# HISTORIC AND DESIGN REVIEW COMMISSION

February 15, 2023

**HDRC CASE NO:** 2023-034  
**ADDRESS:** 116 CAMARGO  
**LEGAL DESCRIPTION:** NCB 923 BLK 4 LOT E 49.8 FT OF 3  
**ZONING:** RM-4, H  
**CITY COUNCIL DIST.:** 1  
**DISTRICT:** Lavaca Historic District  
**APPLICANT:** Nathan Manfred/French & Michigan  
**OWNER:** Rebecca Trujillo/VILLARREAL CARLOS & TRUJILLO REBECCA  
**TYPE OF WORK:** Partial demolition, additions, porch modifications  
**APPLICATION RECEIVED:** January 24, 2023  
**60-DAY REVIEW:** Not applicable due to City Council Emergency Orders  
**CASE MANAGER:** Edward Hall

2 116 CAMARGO - DEMO PLAN  
SCALE: 1/4" = 1'-0"

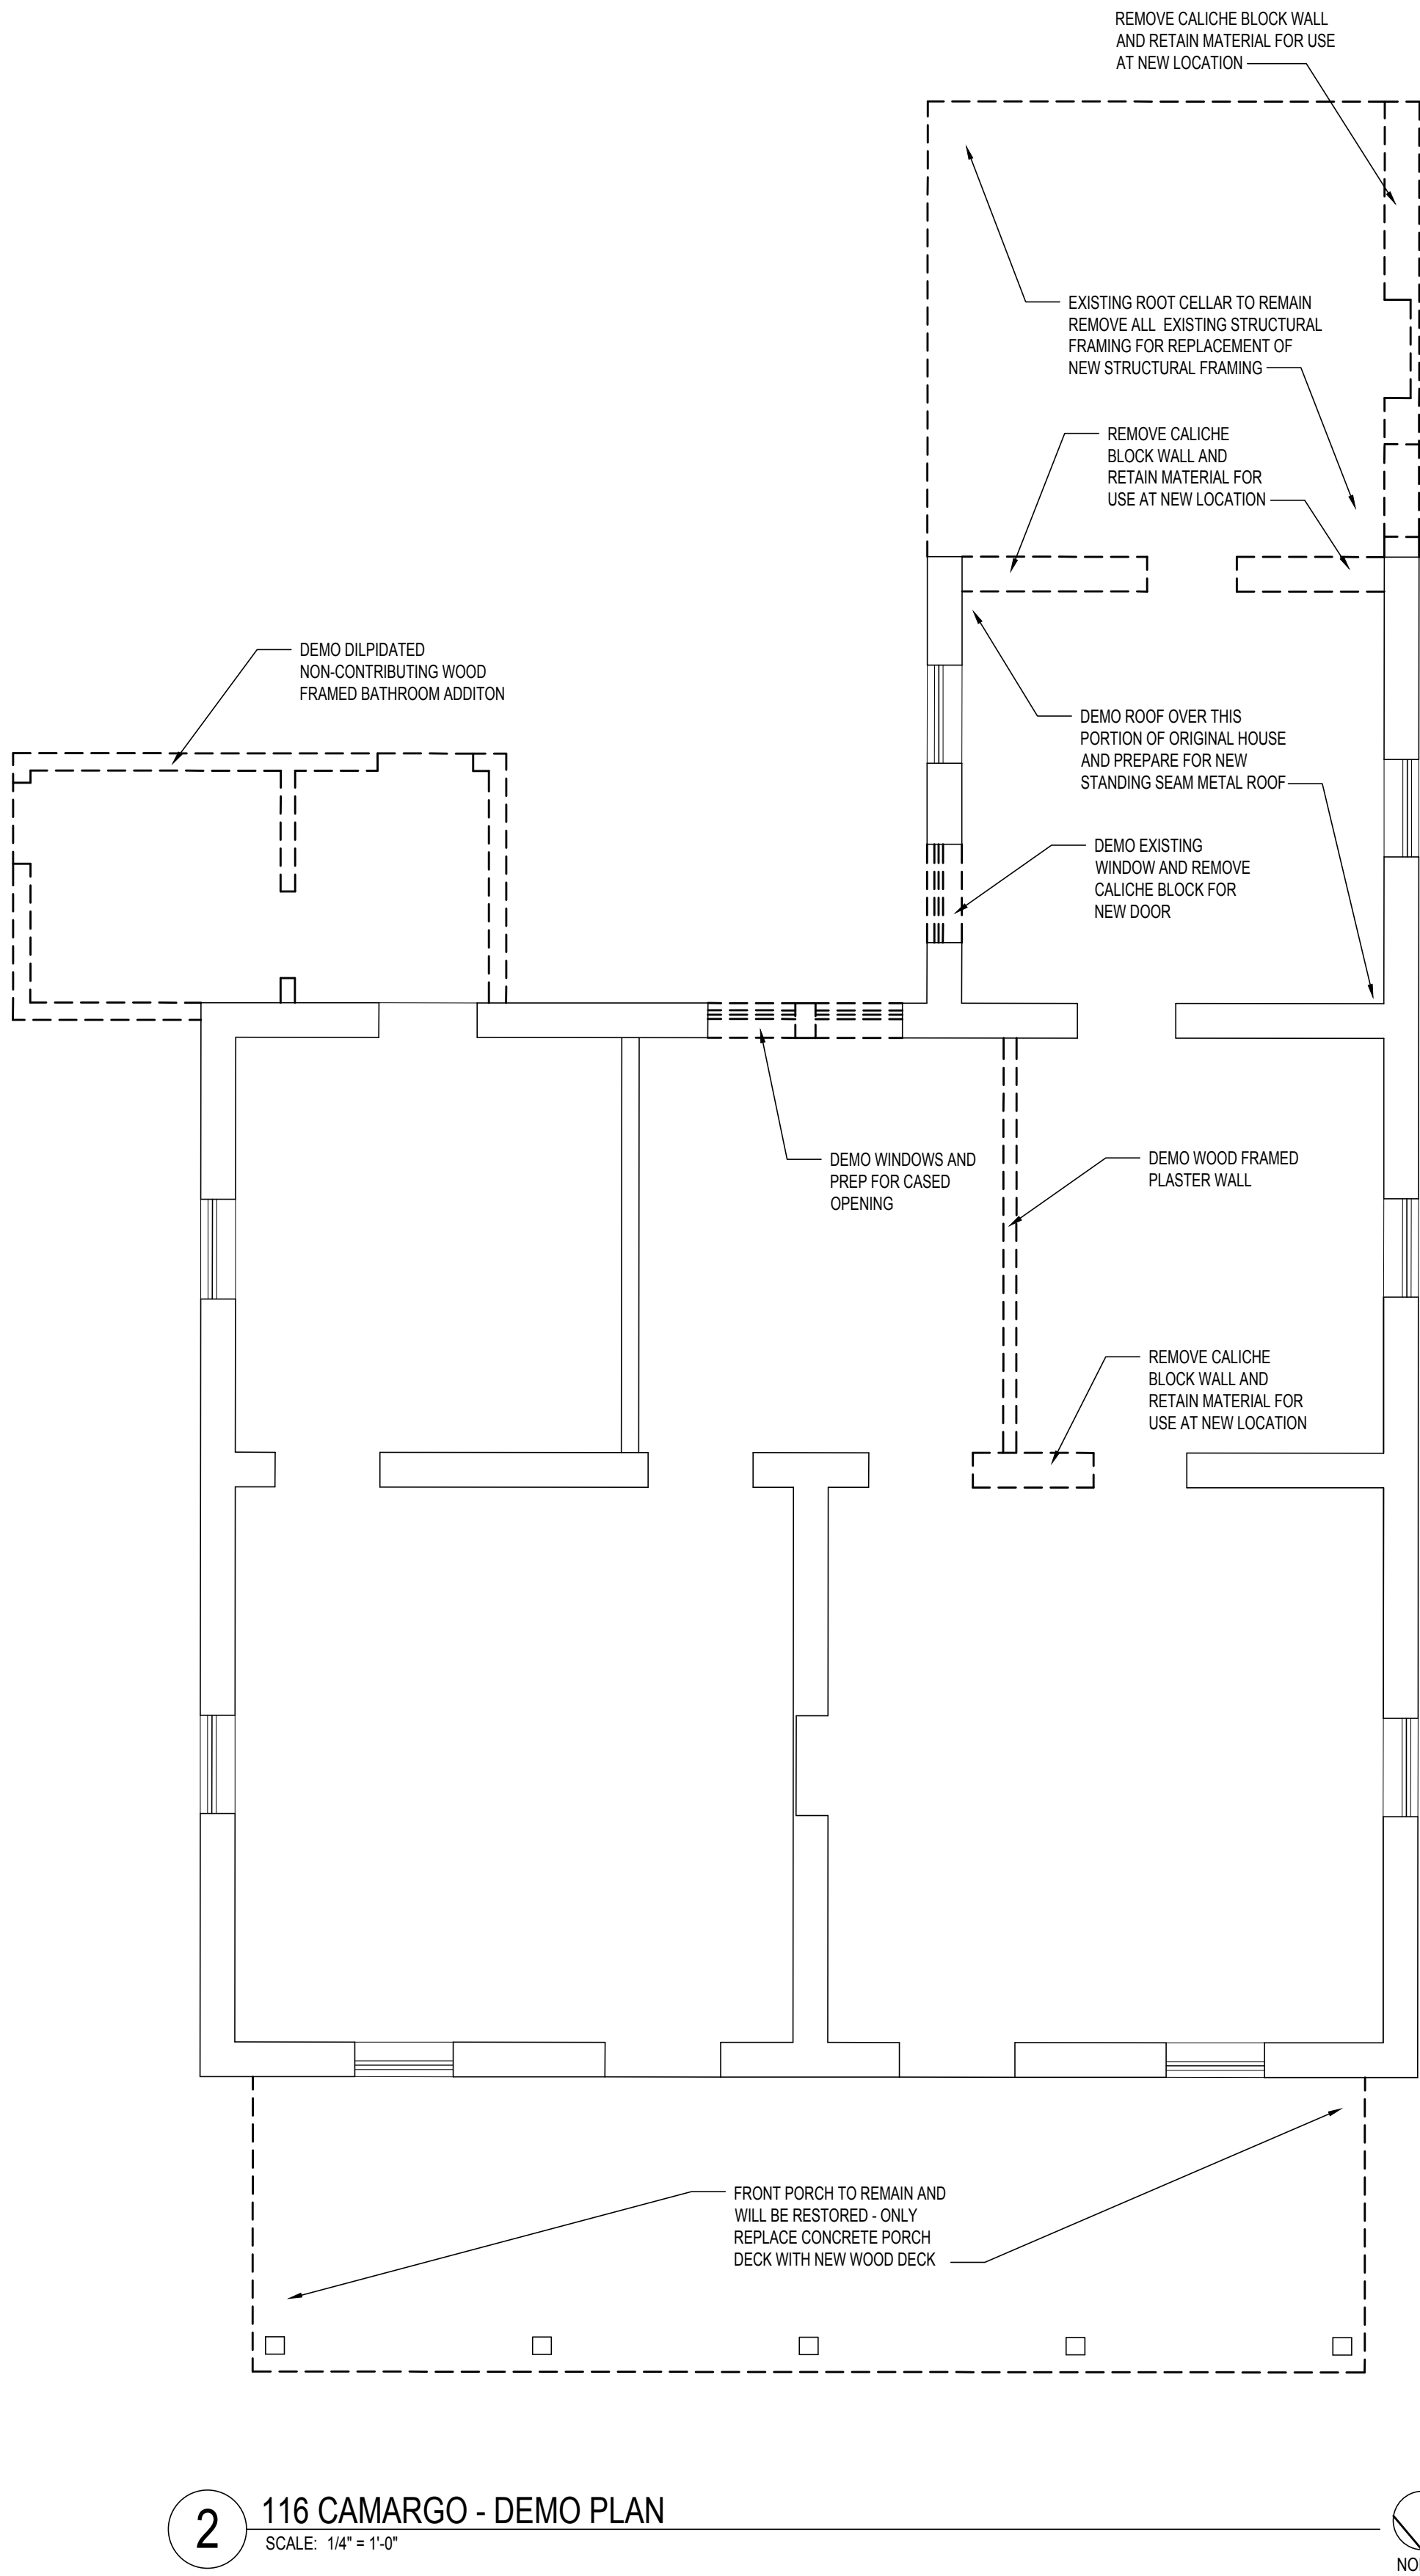
- d. BATH ADDITION – The applicant has proposed to remove an existing, non-contributing, wood framed addition and construct a 152 square foot addition. The existing, wood-framed structure that has been proposed to be removed does not appear on the 1951 Sanborn Map. Staff finds this removal of this addition to be appropriate.

- h. REMOVAL OF STONE WALLS – The applicant has proposed to remove existing, original stone wall on the west side of the historic structure at the rear and construct a new wood framed addition to feature 272 square feet. The caliche stone wall that has been proposed to be removed is found on the 1896 Sanborn Map and is likely an original wall. The wall is currently the remaining element of a rear wing that once featured east and south walls, a roof structure and porch. Staff finds the rear wall to be a character defining feature of this structure.

- i. REMOVAL OF STONE WALLS – Staff performed a site visit on February 6, 2023, and viewed the condition of the remaining wall. Staff found the original wall to be in a significant state of deterioration. Based on current conditions, staff find that significant interventions are needed to preserve and rehabilitate this wall. Staff is supportive of the dismantling of this wall and the salvaging of its original materials. A detailed salvage plan should be submitted to OHP staff for review and approval prior to the issuance of a Certificate of Appropriateness. The applicant has noted that materials will be immediately salvaged for use in repair to the primary historic structure's walls, specifically regarding plate heights.

- iii. That the proposed wood windows remain consistent with the adopted window policy document.
3. Staff recommends approval of item #3, the removal of original stone walls and the construction of a rear bedroom addition based on findings h through l with the following stipulations:

- iii. That the proposed wood windows remain consistent with the adopted window policy document.
  - iv. That a detailed salvage plan be submitted to OHP staff for review and approval of the stone from the original caliche walls.
4. Staff recommends approval of item #4, the construction of a rear accessory structure based on findings m through q with the following stipulations:
- i. That board and batten siding feature boards that are approximately 12 inches wide with battens that are approximately 1 – ½” wide. If composite siding is used, it should feature a smooth finish.
  - ii. Standing seam metal roofing should feature panels that are 18 to 21 inches wide, seams that are 1 to 2 inches in height, a standard galvalume finish and a crimped ridge seam or ridge sleeve. Panels should be smooth with no corrugation or striations.
